TYLIN INTERNATIONAL	USER NAME =	DESIGNED - EMK	REVISED Δ - ADDENDUM 1 05/24/10
	PLOT SCALE =	DRAWN - EMK	REVISED -
	PLOT DATE =	CHECKED - JDU	REVISED -
		DATE - 3/18/2010	REVISED -

I-57 AT I-294 INTERCHANGE PROJECT			
PAVEMENT MARKING AND LANDSCAPING PLANS			
SCALE: 1"=50'	SHEET NO. 7 OF 10 SHEETS	STA. 1247+00 TO STA. 1261+50

F.A.I. RTE.	SECTION	COUNTY	TOTAL SHEETS	SHEET NO.
57	1414.2B	COOK	516	197
FED. ROAD DIST. NO. ILLINOIS FED. AID PROJECT			CONTRACT NO. 60J27

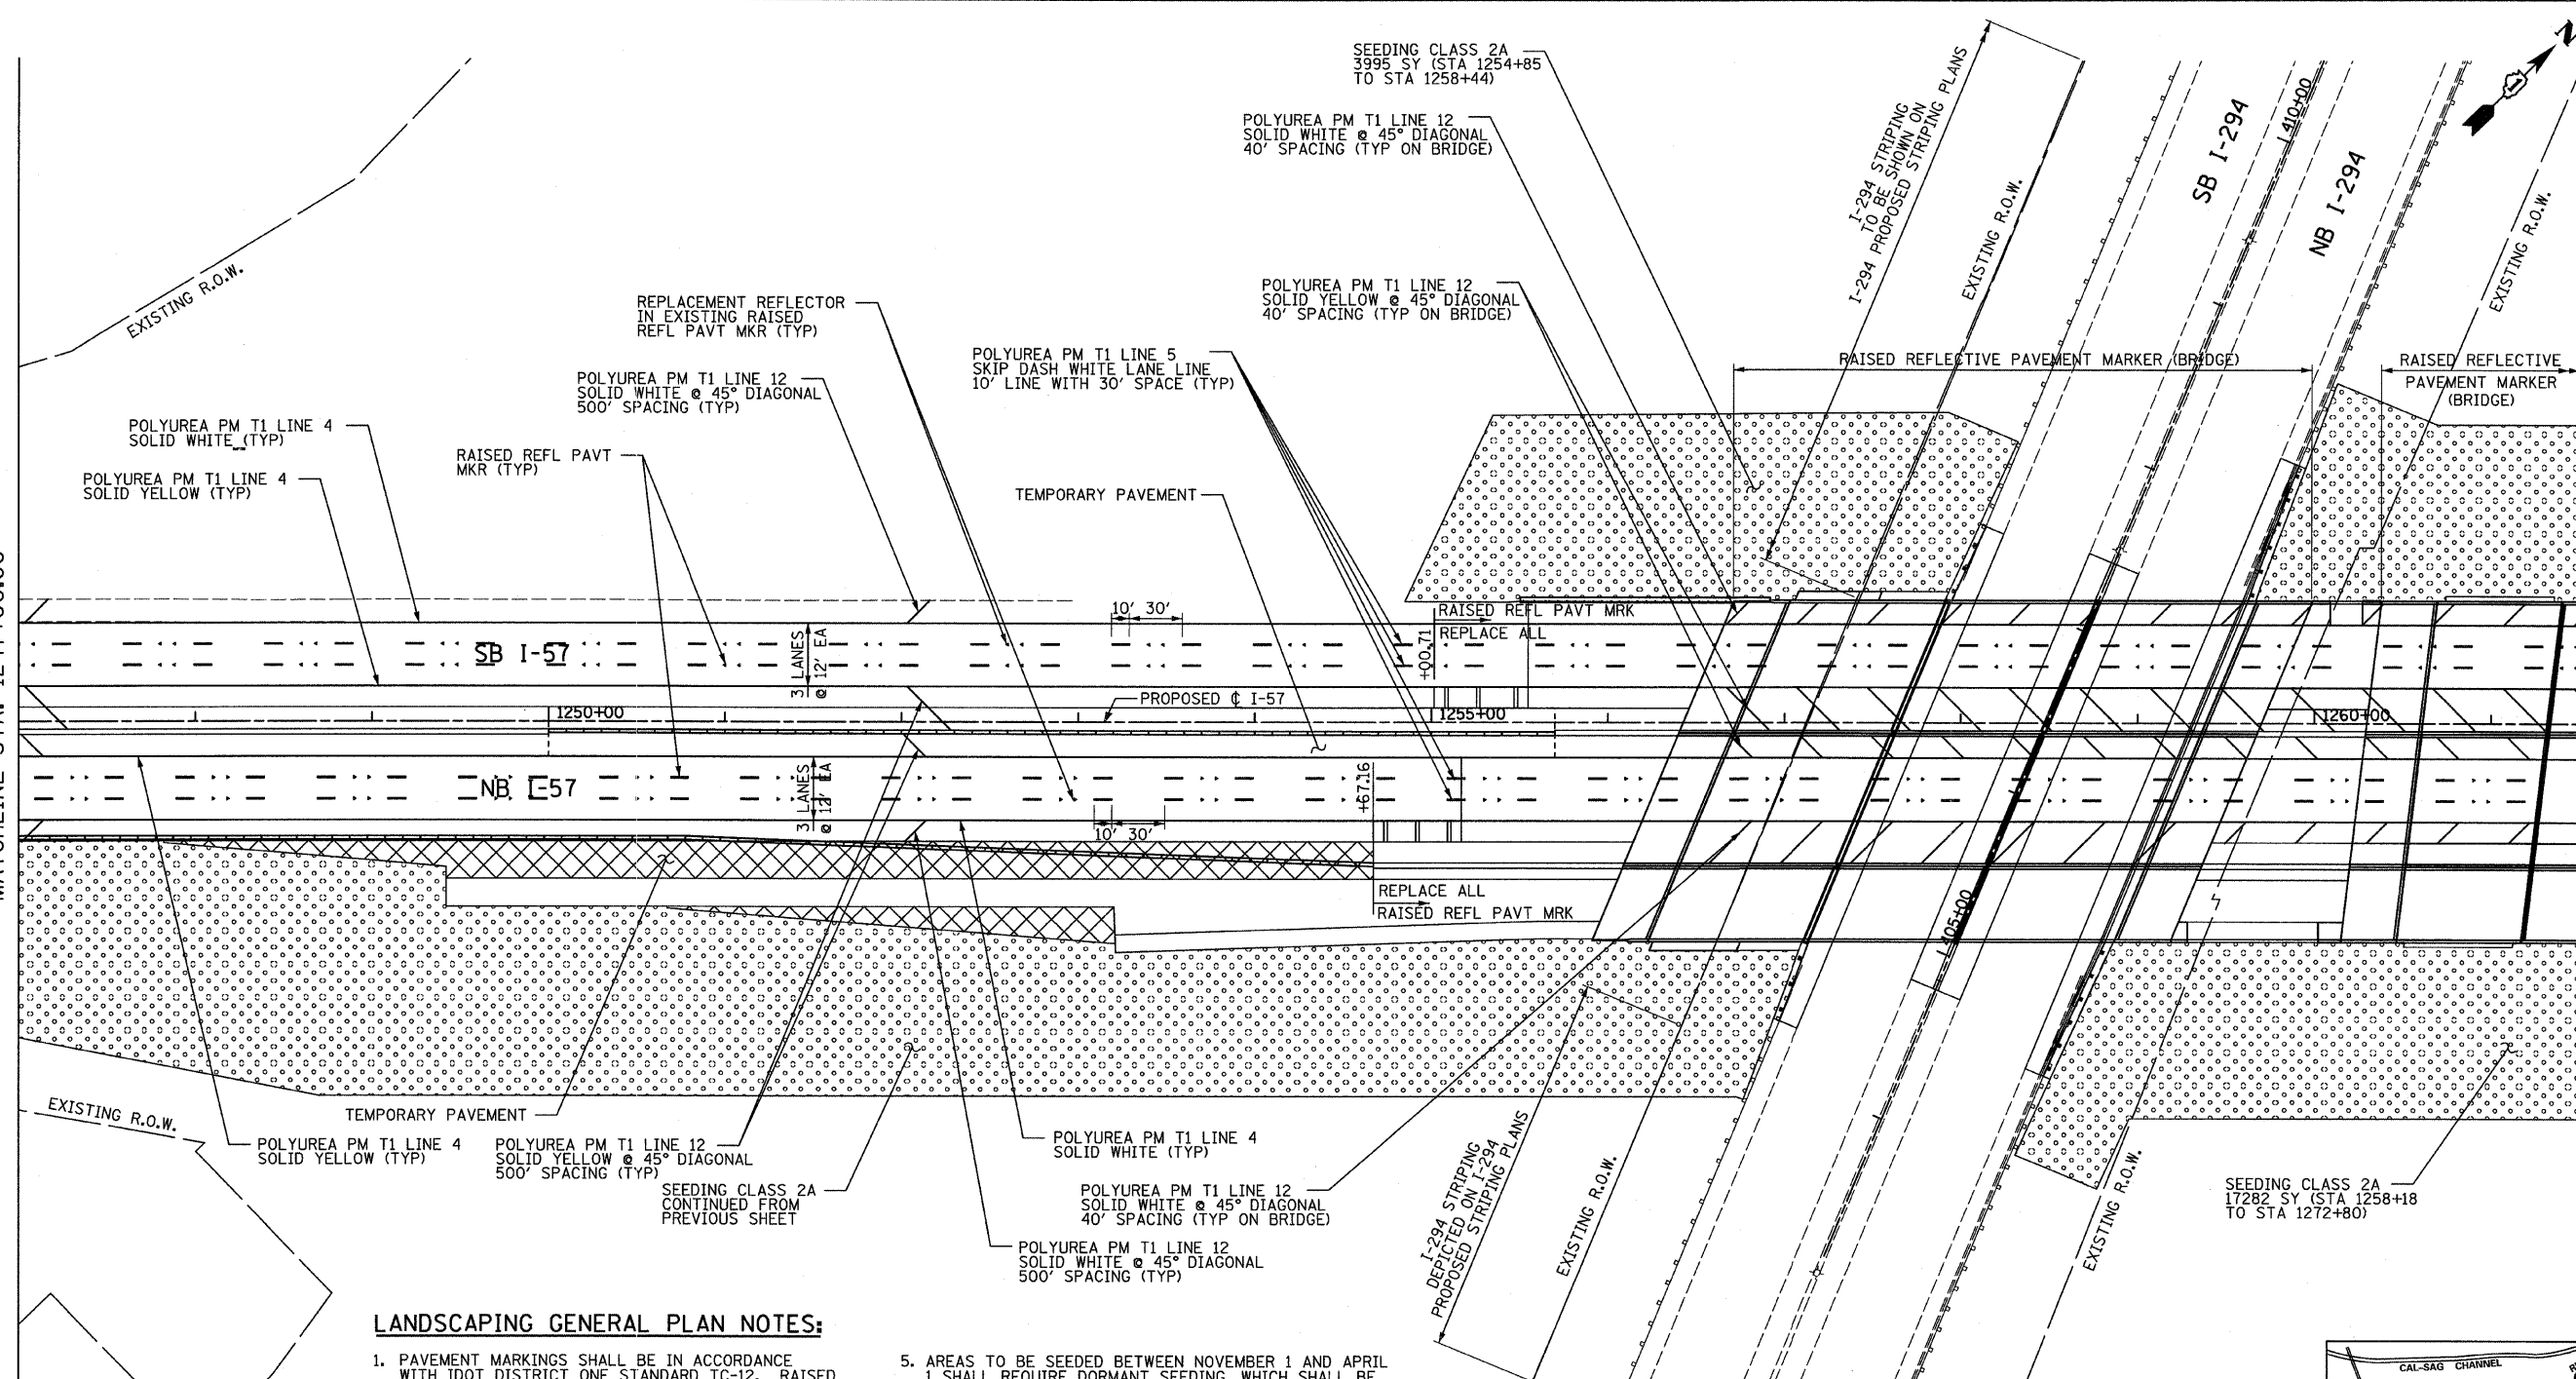
PAVEMENT MARKING NOTE:
 ALL PAVEMENT MARKINGS ALONG I-57 LABELED AS POLYUREA SHALL BE THERMOPLASTIC WITH THE EXCEPTION OF SB I-57 FROM STA. 1255+54.91 TO STA. 1263+20.86 AND NB I-57 STA. 1255+17.16 TO STA. 1263+11.79.
